# HISTORIC AND DESIGN REVIEW COMMISSION

**HDRC CASE NO:** 2022-255  
**COMMON NAME:** 2219 W Gramercy  
**LEGAL DESCRIPTION:** NCB 6820 BLK LOT 7  
**ZONING:** R-6, H  
**CITY COUNCIL DIST.:** 7  
**DISTRICT:** Monticello Park Historic District  
**APPLICANT:** Michael Clancy  
**OWNER:** James and Jennifer Bailey  
**TYPE OF WORK:** New construction of a 1-story, single-family residential structure  
**APPLICATION RECEIVED:** April 29, 2022  
**60-DAY REVIEW:** Not applicable Due to City Council Emergency Orders  
**CASE MANAGER:** Rachel Rettaliata

The applicant is requesting conceptual approval to construct a new 1-story, single-family residence at 2219 W Gramercy.

**Historic and Design Review Commission**  
***Design Review Committee Report***

**2219 W. GRAMERCY PLACE - SINGLE FAMILY HOME**  
**SOUTH - STREET FACING ELEVATION**

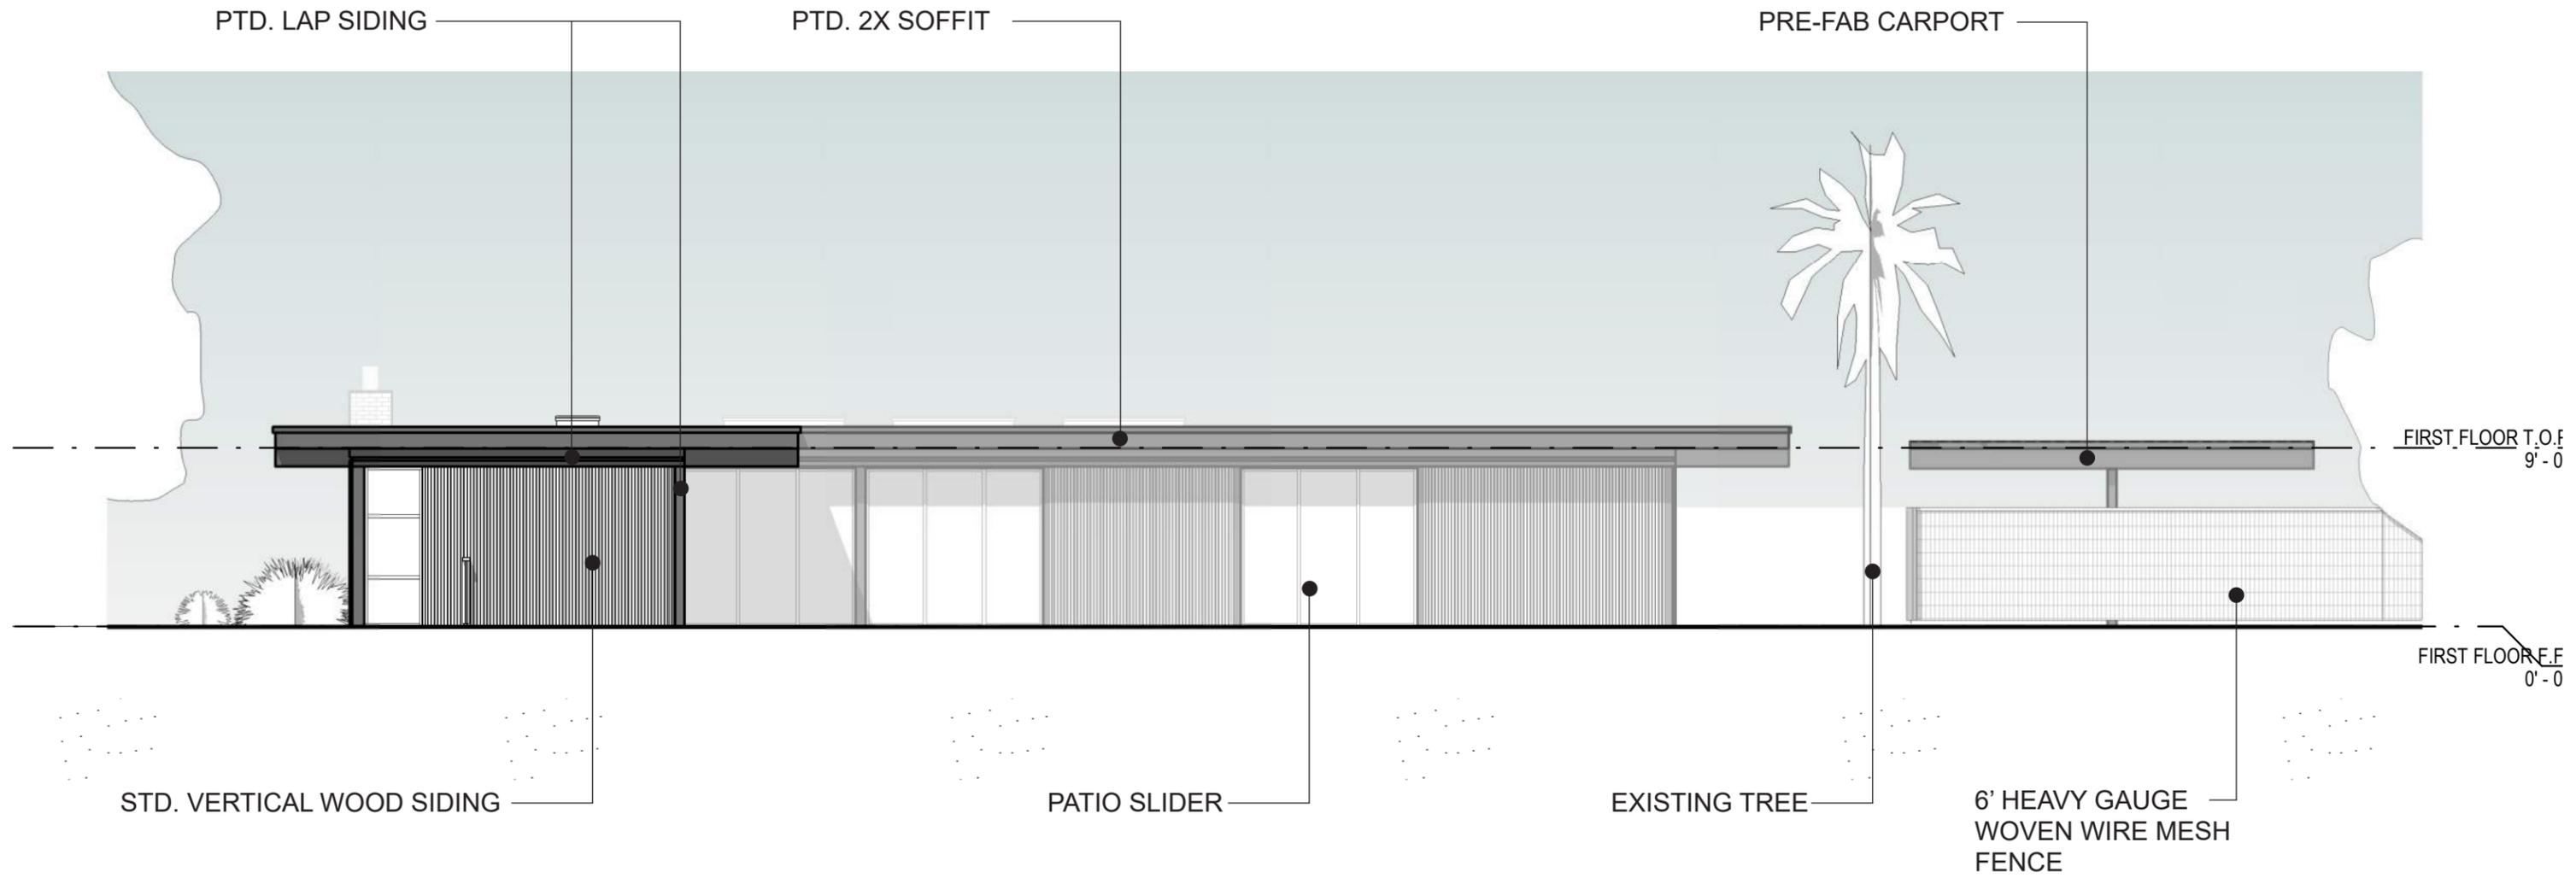
LG: LG: Would this be the only house on the street not oriented to the street?

JB: The entry is to the street, through the gates.

LG: It is respectful on a street with more traditional roof forms, I don't think I'm agreeing with it looking like an accessory structure. I think it's going to look like a house and the other

mid-century houses shown were acknowledging the entrance. It is still introducing something new.

JB: The side porch is cantilevered 6 feet, 7-½ feet, we could drop a column down and put a nice set of wood doors there.

LG: An entrance acknowledging that there is an entry facing the street.

MS: I think that the volumes that accompany the entry help to make it appear as an entry way with surrounding volumes on either side. I think that's what missing from the entry sequence.

**DON YOUNG ALUM. WINDOW**  
 COLOR - DARK BRONZE  
 STYLE - AWNING

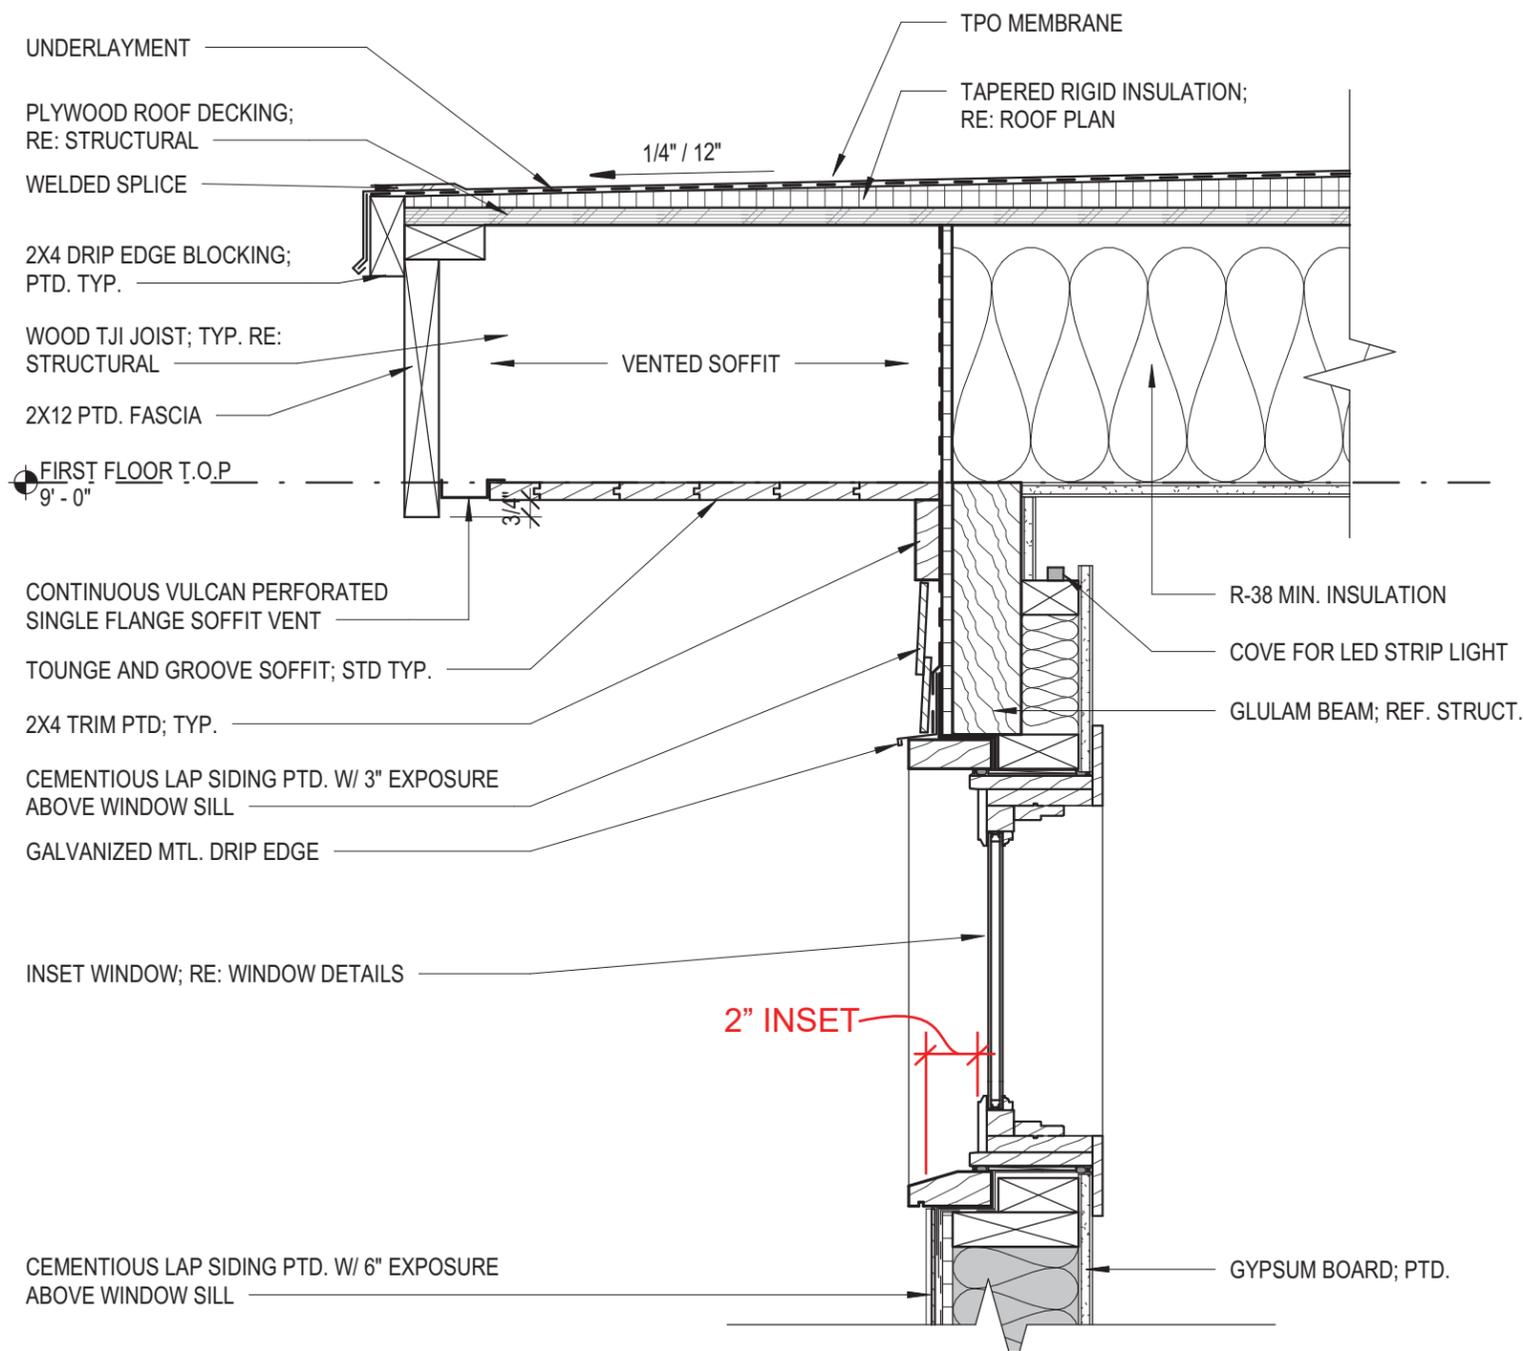
- h. WINDOW MATERIALS – The applicant has proposed to install Don Young aluminum awning windows in dark bronze. Wood or aluminum-clad wood windows are recommended and should feature an inset of two (2) inches within facades and should feature profiles that are found historically within the immediate vicinity. An alternative window material may be proposed, provided that the window features meeting rails that are no taller than 1.25” and stiles no wider than 2.25”. White manufacturer’s color is not allowed, and color selection must be presented to staff. There should be a minimum of two inches in depth between the front face of the window trim and the front face of the top window sash. This must be accomplished by recessing the window sufficiently within the opening or with the installation of additional window trim to add thickness. Window trim must feature traditional dimensions and an architecturally appropriate sill detail. Window track components must be painted to match the window trim or be concealed by a wood window screen set within the opening. Faux divided lites are not permitted. Staff finds that the applicant should submit final product specifications to staff for review prior to returning to the HDRC.

- ii. That the applicant submits final window specifications to staff for review prior to returning to the HDRC based on finding h. Wood or aluminum-clad wood windows are recommended and should feature an inset of two (2) inches within facades and should feature profiles that are found historically within the immediate vicinity. An alternative window material may be proposed, provided that the window features meeting rails that are no taller than 1.25" and stiles no wider than 2.25". White manufacturer's color is not allowed, and color selection must be presented to staff. There should be a minimum of two inches in depth between the front face of the window trim and the front face of the top window sash. This must be accomplished by recessing the window sufficiently within the opening or with the installation of additional window trim to add thickness. Window trim must feature traditional dimensions and architecturally appropriate sill detail. Window track components must be painted to match the window trim or concealed by a wood window screen set within the opening.
